Licence Number L7815/2001/11

Licence Holder Saracen Metals Pty Ltd

Premises North Eastern Goldfields Operations

Amendment

Figure 4: Underdrainage detail for TSF expansion construction (Drawing 1 of 2) (Knight Piesold 2017c)

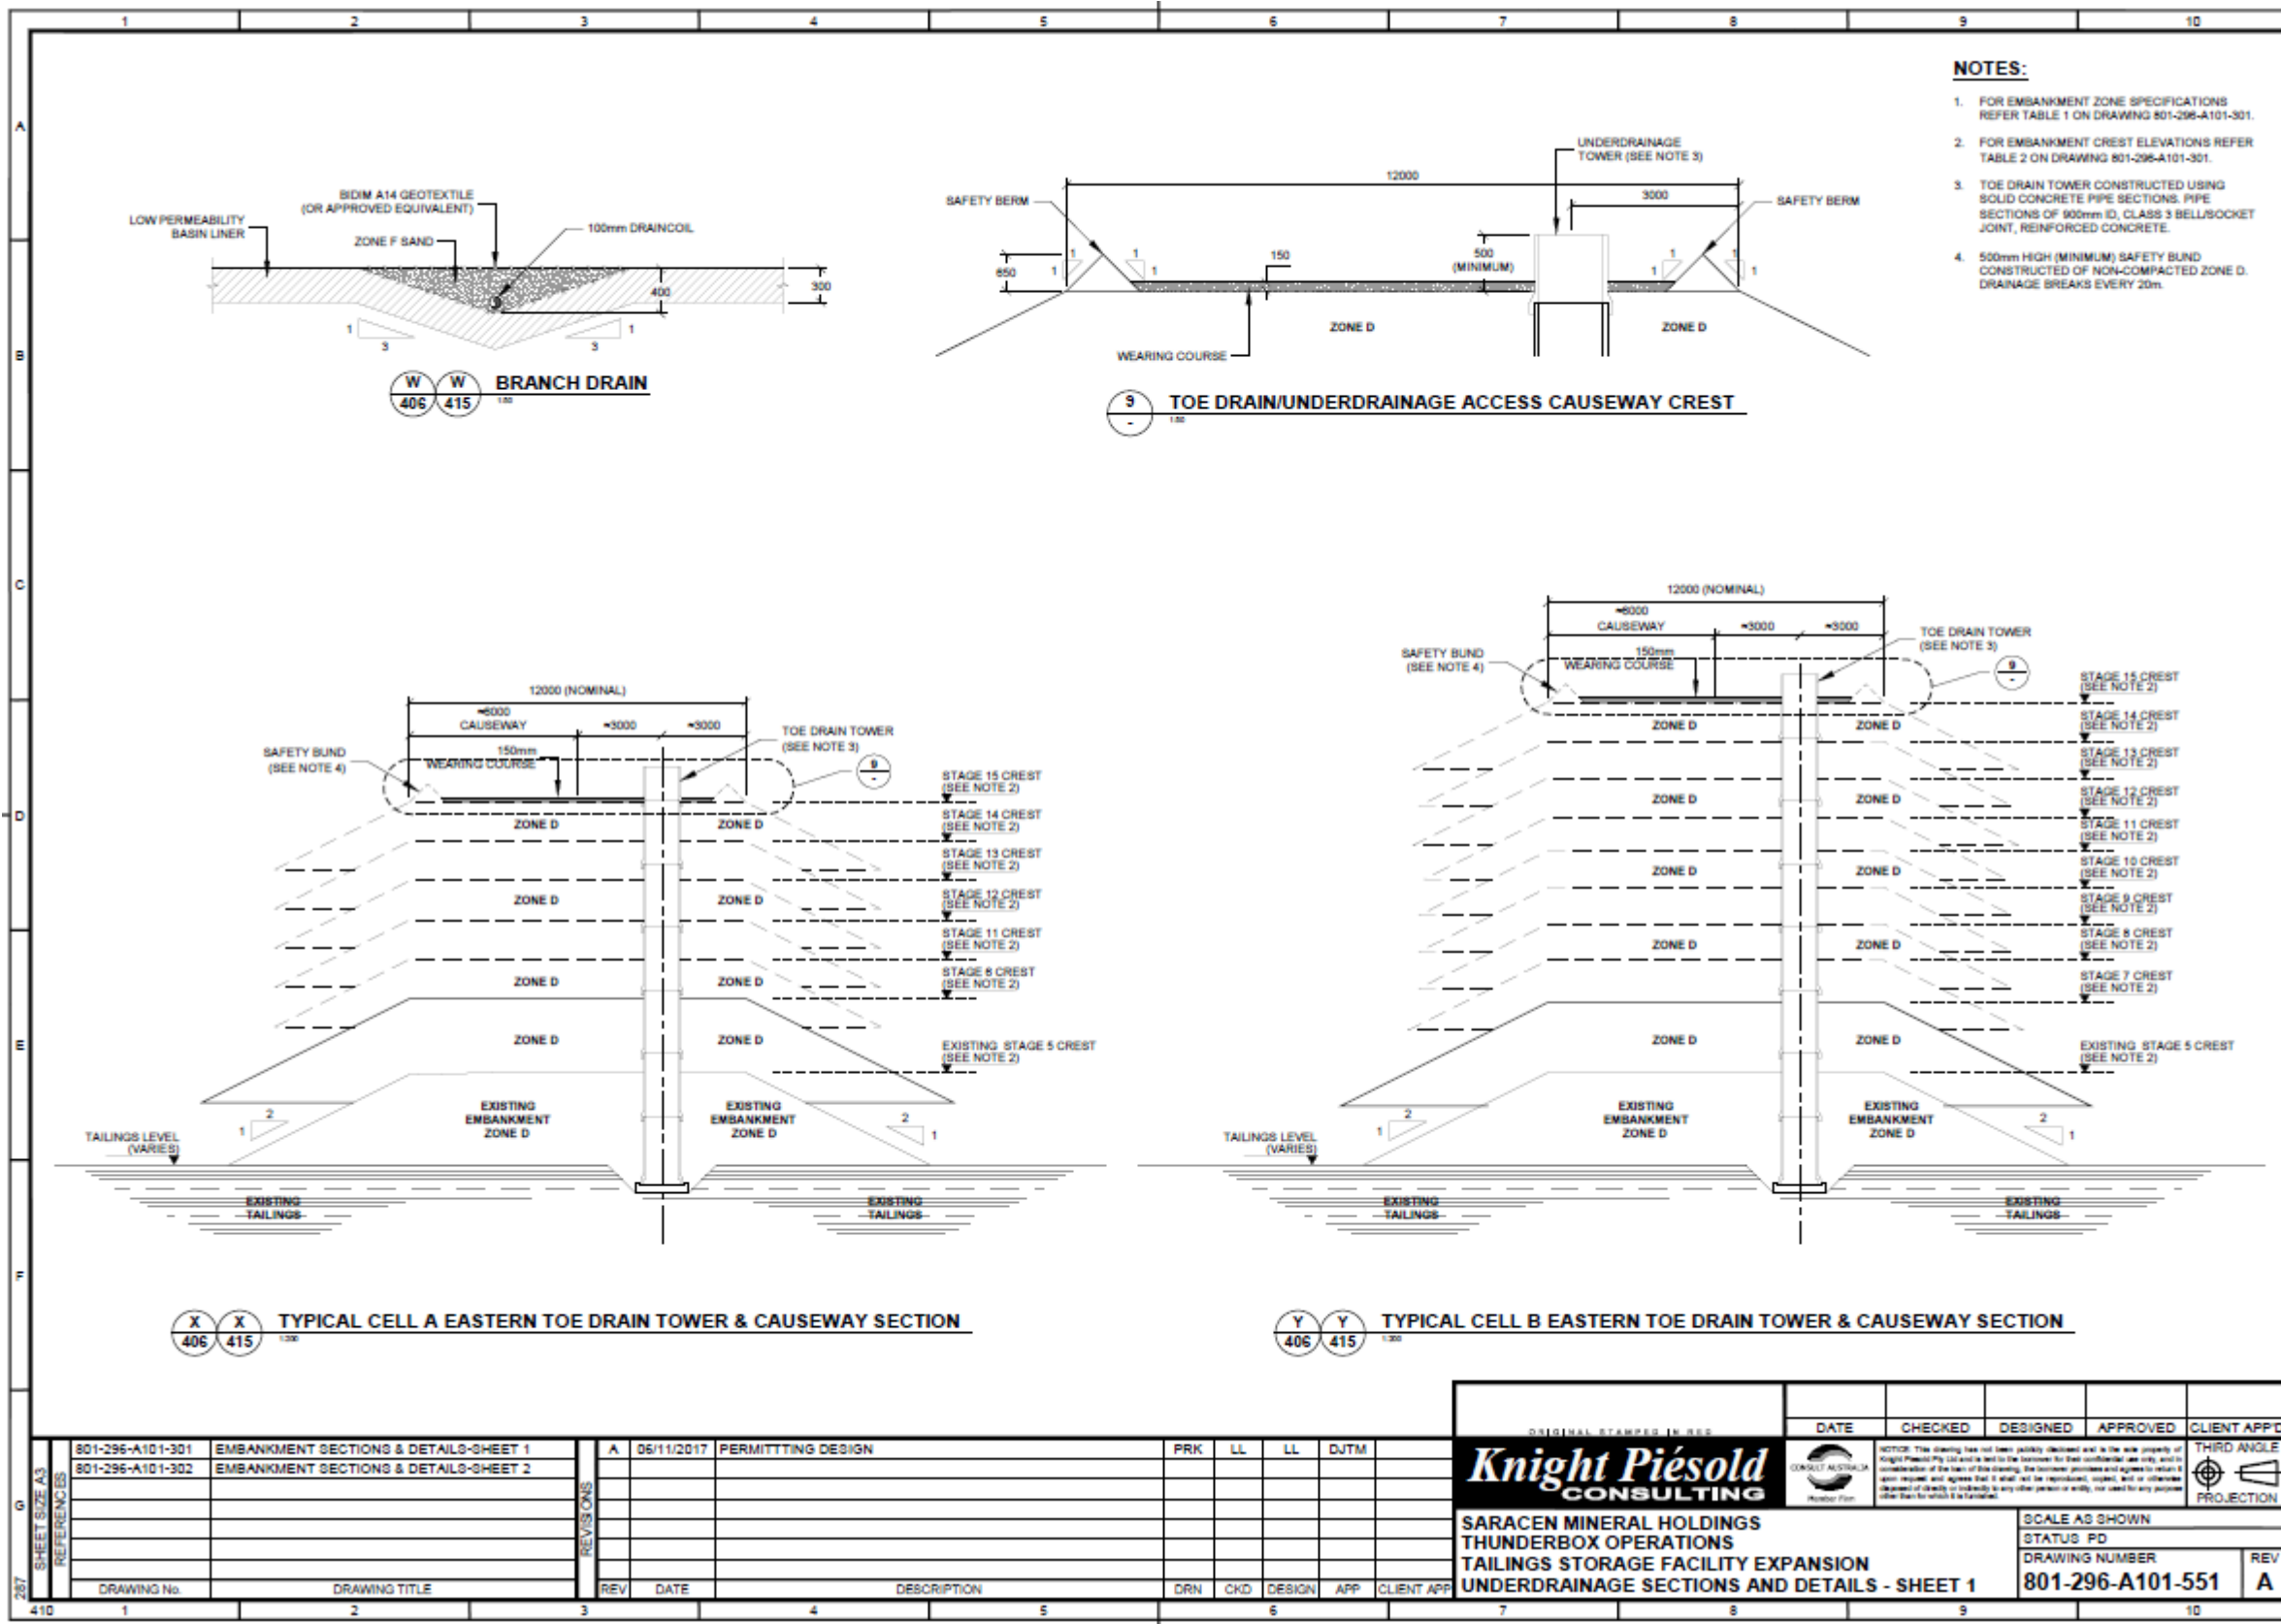
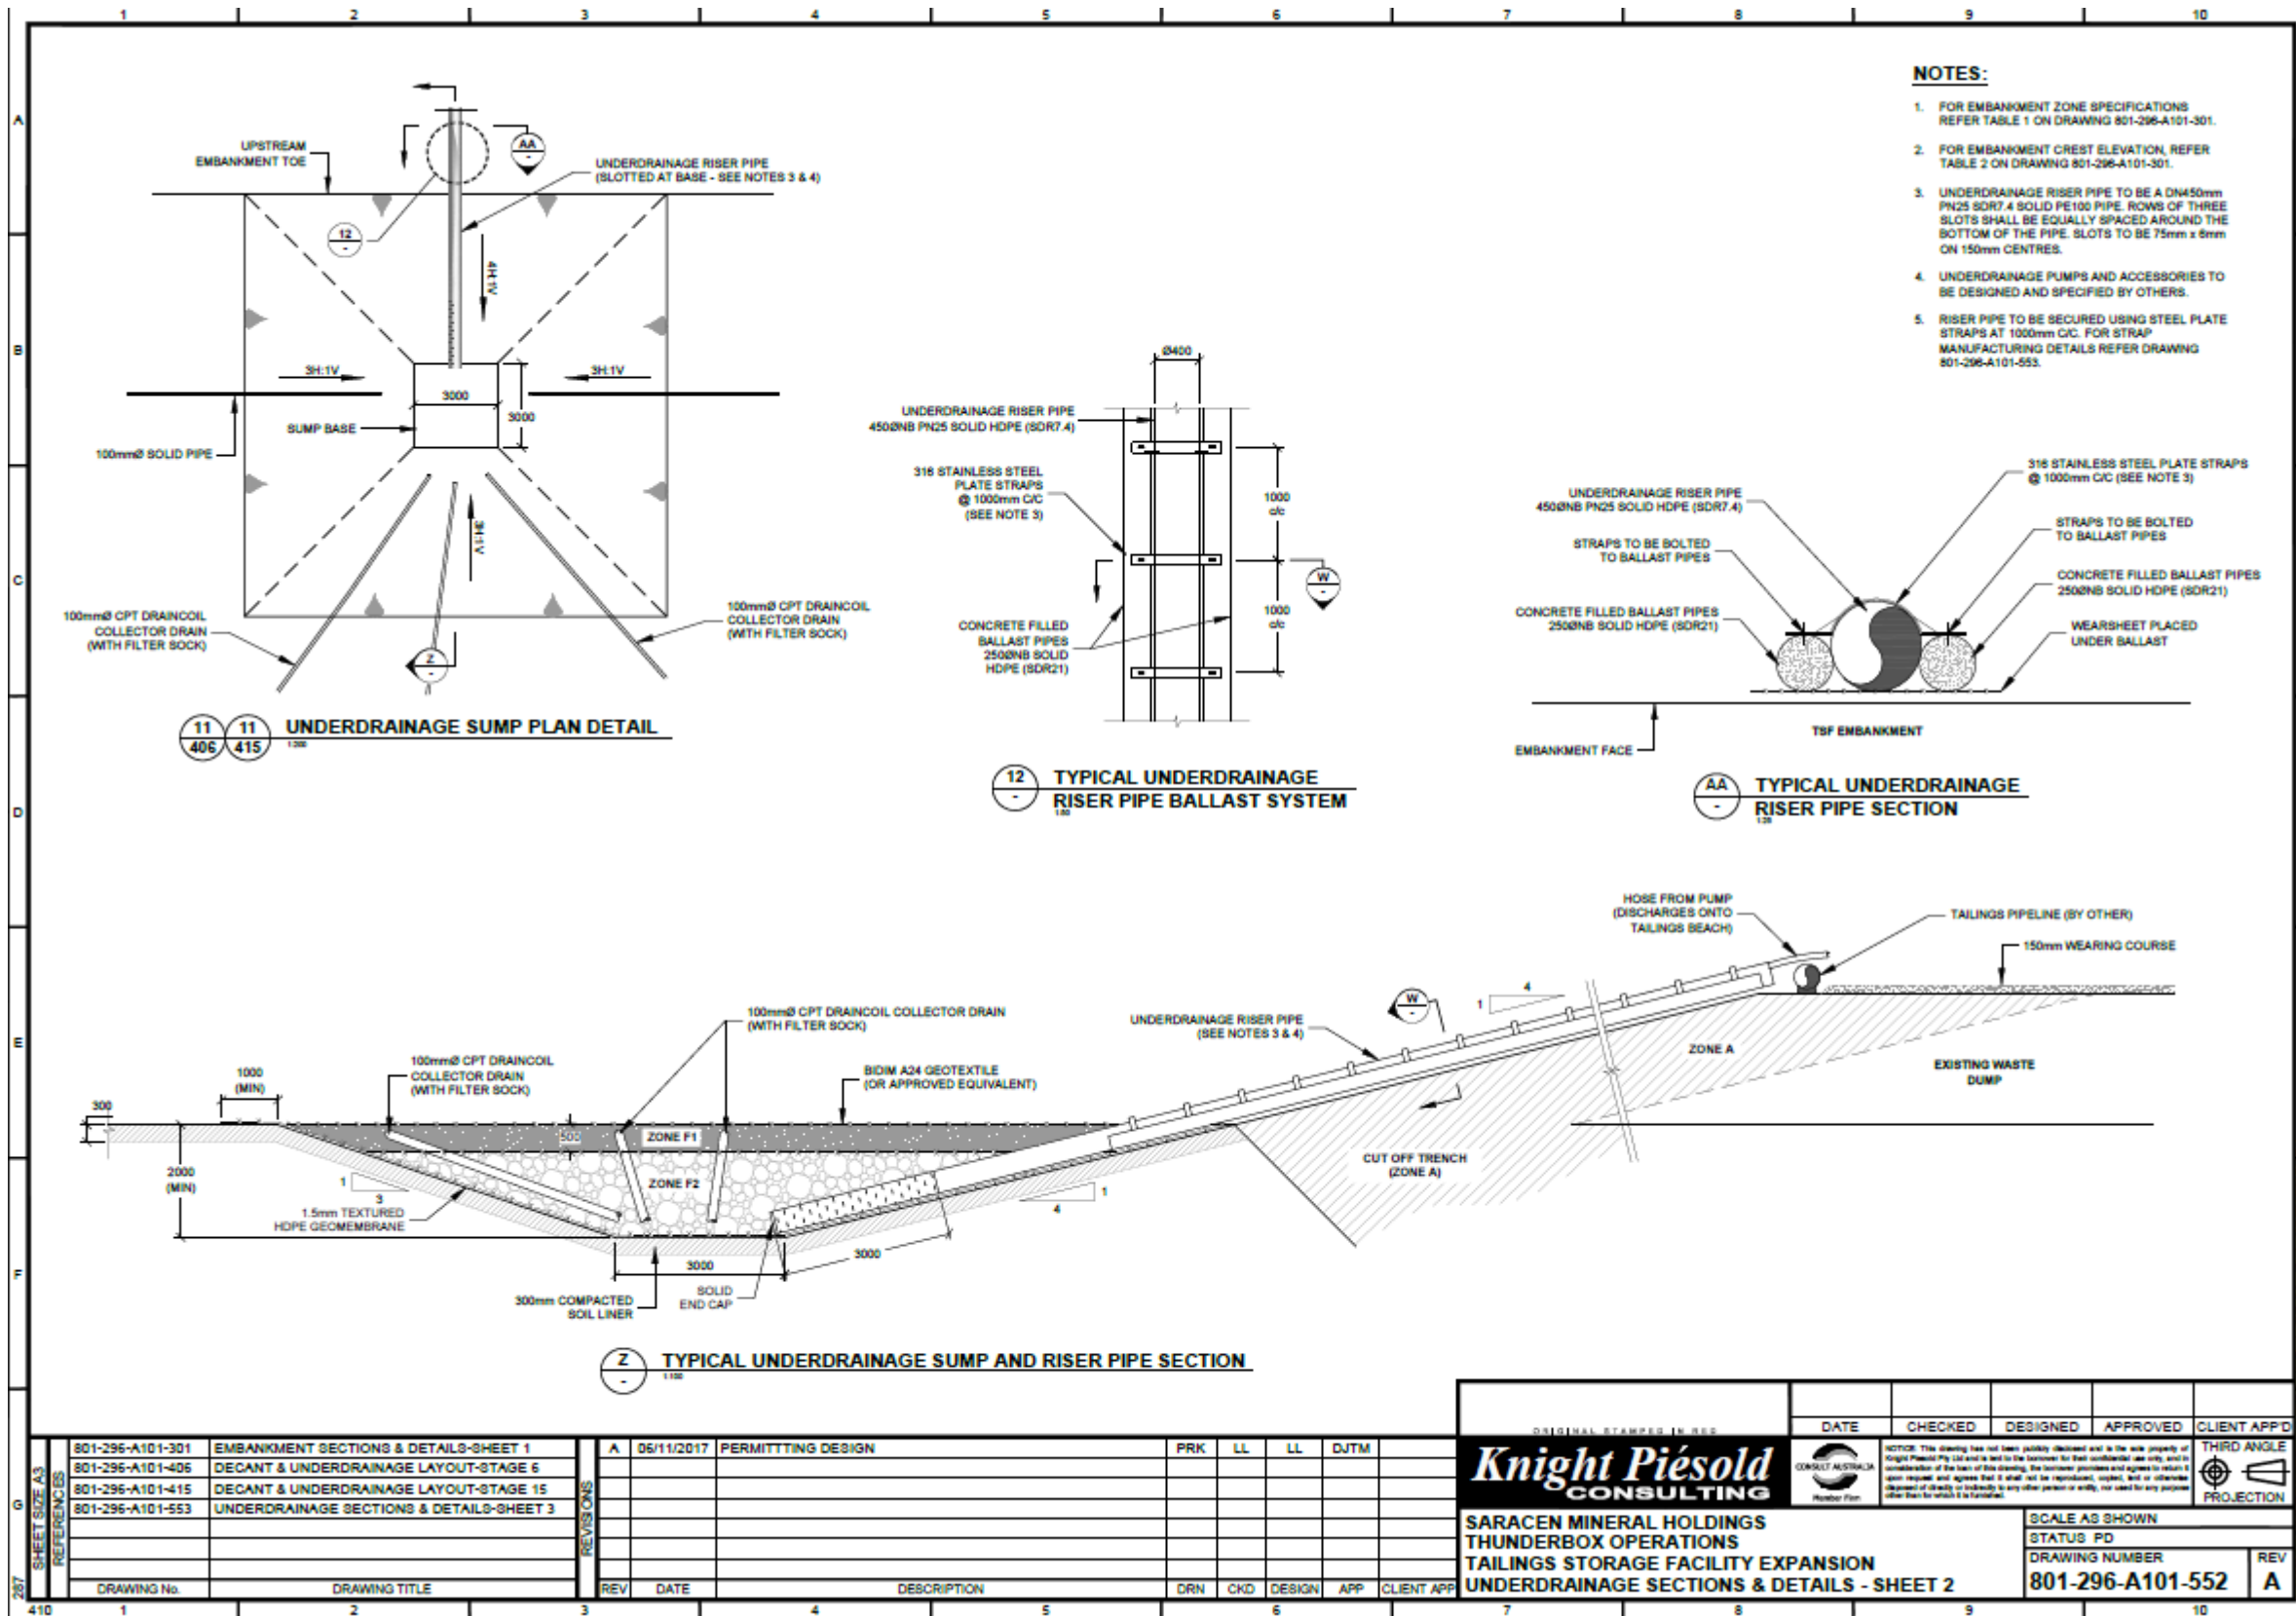
The new expansion area to the west of the existing cells introduces the potential of increased seepage through the soil layer of the expansion area. To mitigate this risk, the TSF design has incorporated a 300mm compacted soil liner over the entire basin area, with a 200mm protection layer over the compacted soil liner to prevent erosion prior to tailings deposition. Whilst not proposed in the TSF design, the Licensee shall be required to test the hydraulic conductivity of the soil liner and ensure that it meets 1×10^{-8} m/s. An underdrainage collection system with temporary decants will also be required to be installed within the expansion area to manage seepage within the expansion area.

<u>Stage 6 TSF modified Cell A and Cell B design</u>	<ul style="list-style-type: none"> <u>Install a 300mm compacted soil liner over the expansion area as shown in Knight Piesold (2017c) drawing 801-296-A101-106 with a hydraulic conductivity of at least 1×10^{-8} m/s.</u> <u>Install underdrainage collection system within the expansion area as per Knight Piesold (2017c) drawings 801-296-A101-406, 801-296-A101-551 and 801-296-A101-552.</u> 	<p><u>Expansion area as shown in Figure 2 of this Amendment Notice 2.</u></p> <p><u>TSF expansion underdrainage details and location as shown in Figure 3 – 5 of this Amendment Notice 2.</u></p>
<u>Groundwater monitoring bores</u>	<ul style="list-style-type: none"> <u>Installation of nested bores at MB7S (slotted at shallow depth 1mbgl – 5mbgl) MB7D (slotted to encounter groundwater) and MB8S (slotted at shallow depth 1mbgl – 5mbgl) and MB8D (slotted to encounter groundwater) at locations as shown in Knight Piesold (2017c) drawing 801-296-A101-900 (also referred to as Figure 4b in this amendment).</u> 	<u>Monitoring Bores Location as per Figure 4b of Schedule 1.</u>
